## ADDENDUM NO. 1

**Sault Ste. Marie Public Schools  
Middle School Structural Roof  
Repairs and Roof Replacement  
Sault Ste. Marie, Michigan**

ADDENDUM NO. 1 is issued April 11, 2025, to clarify, modify, and/or change the original plans and specifications issued by UP Engineers and Architects. This ADDENDUM NO. 1 is hereby made part of the Contract Documents for the contract noted below.

S101

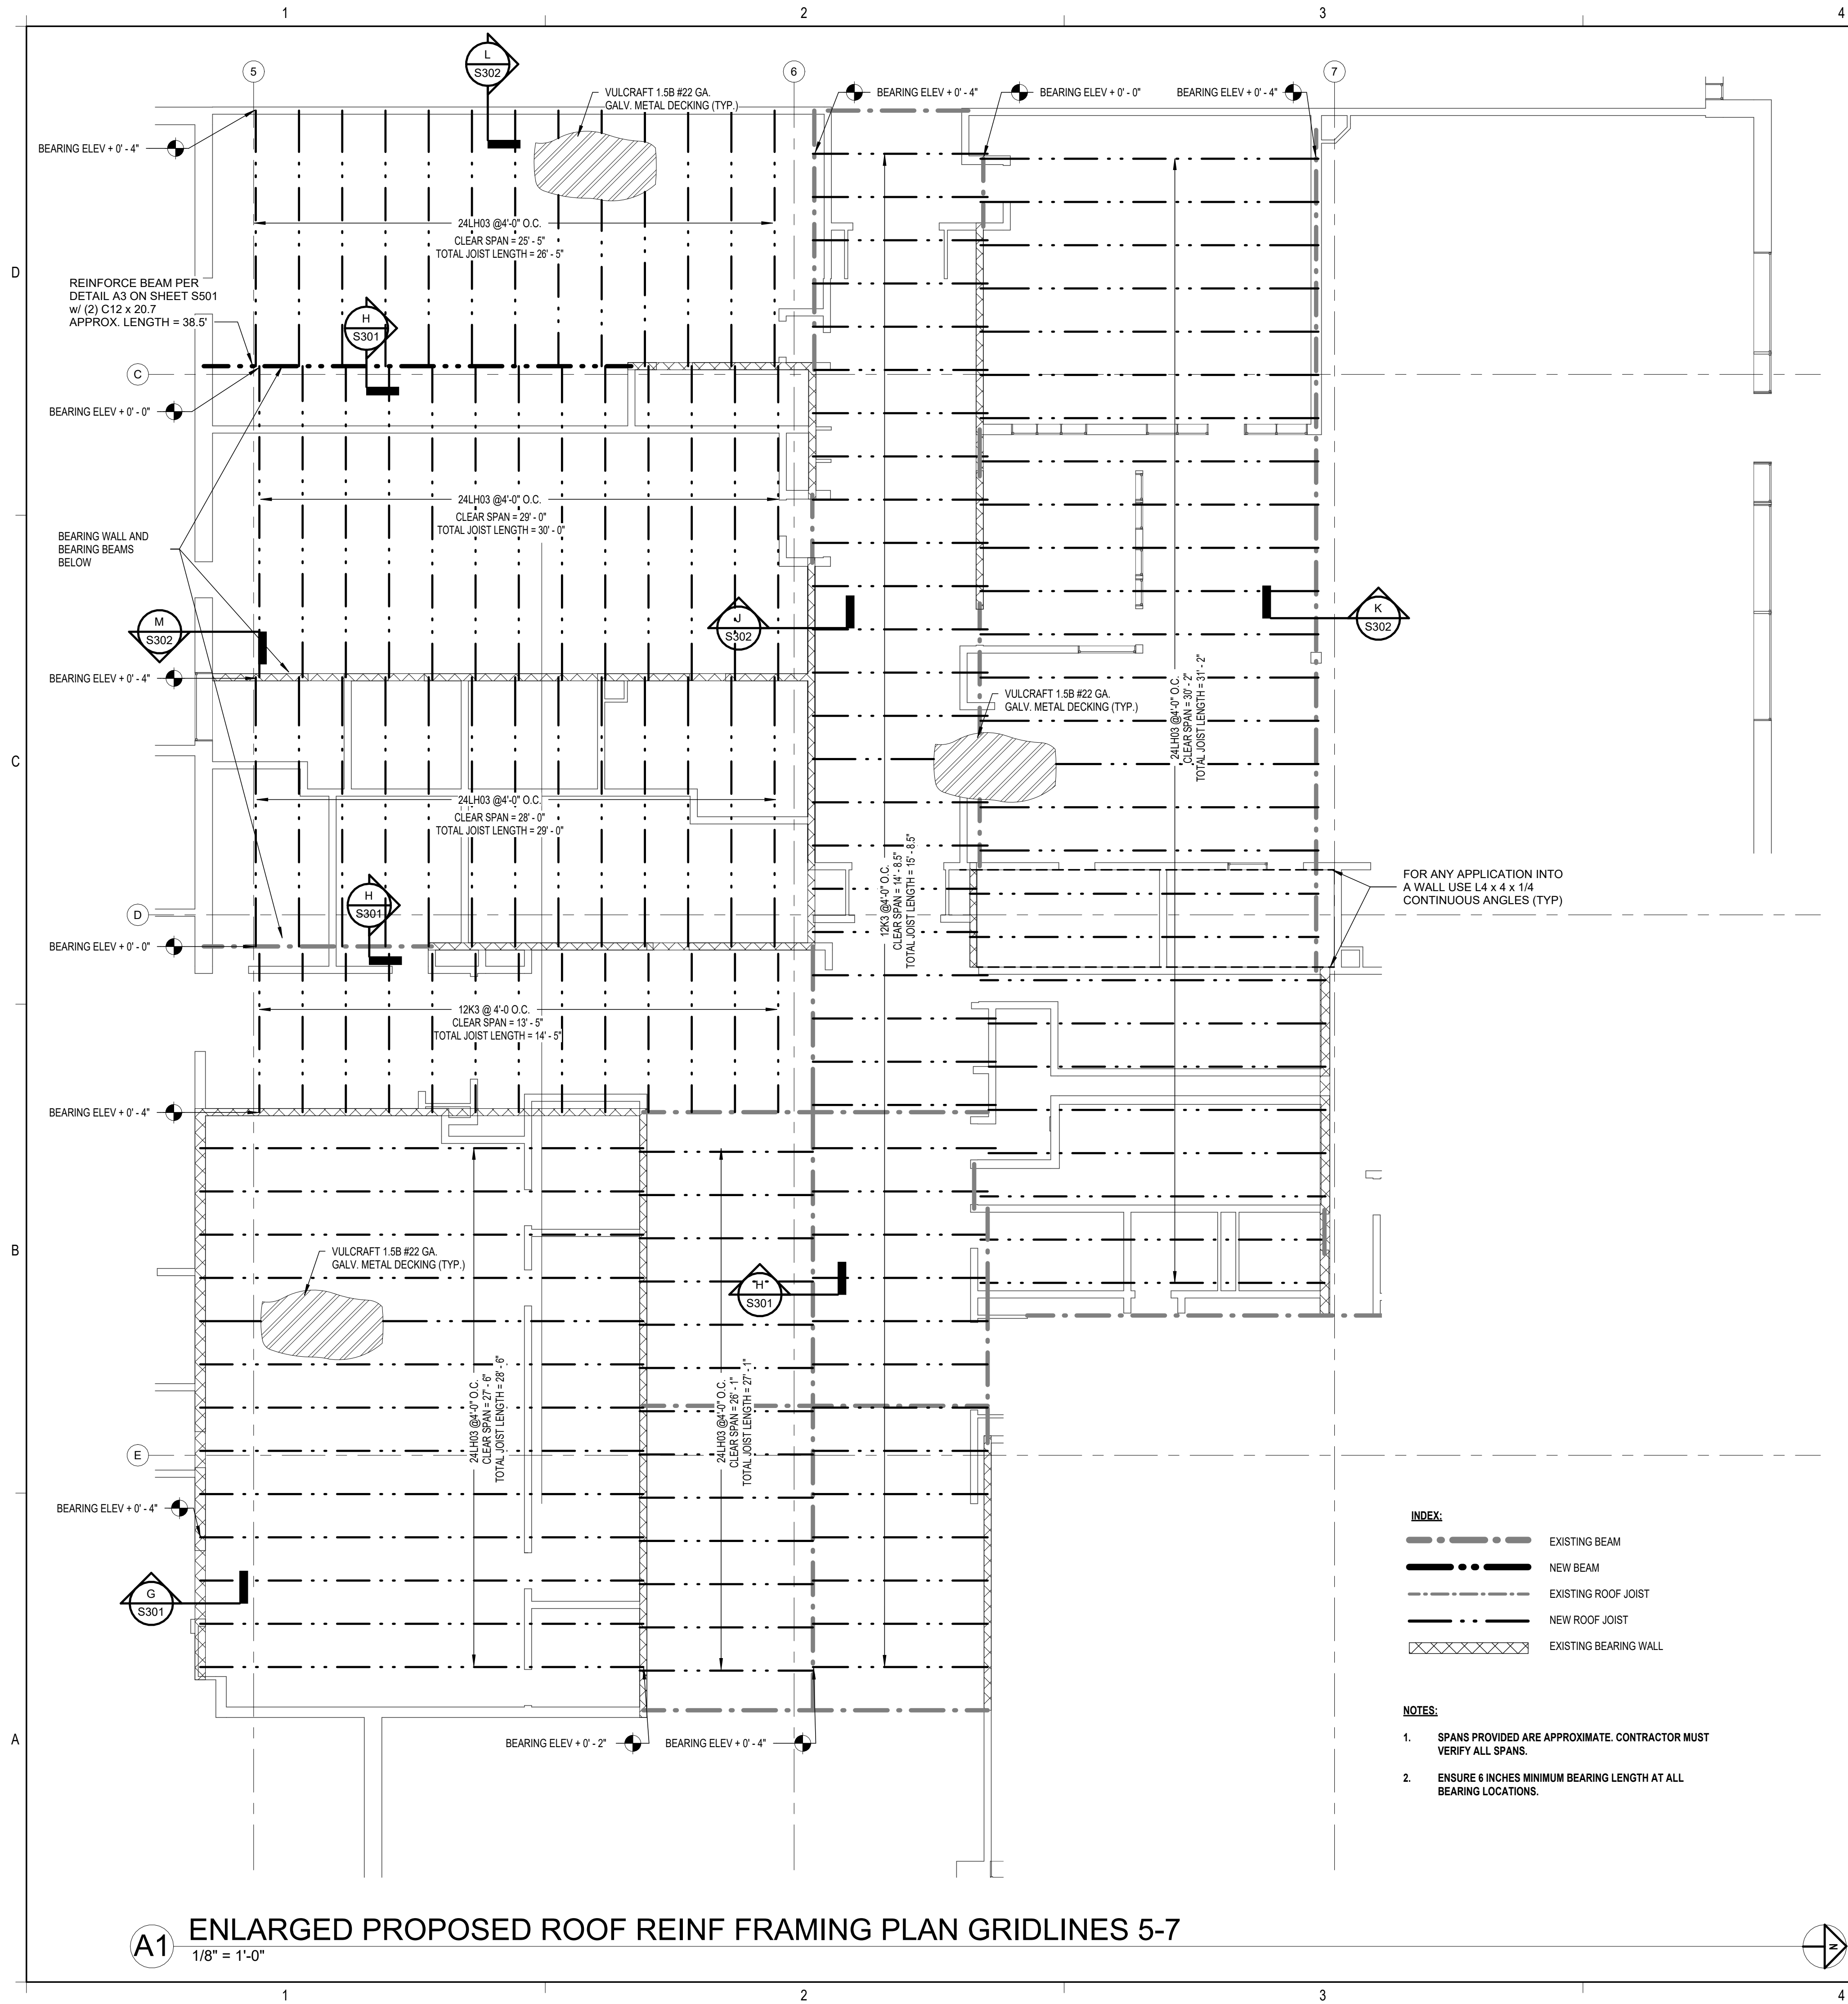
5. See **attached** revised structural details.
  - a. Metal panel at vertical roof extensions.
  - b. Treated plywood on parapet walls.
  - c. Cuts through new beams.
  - d. Denote bearing walls.
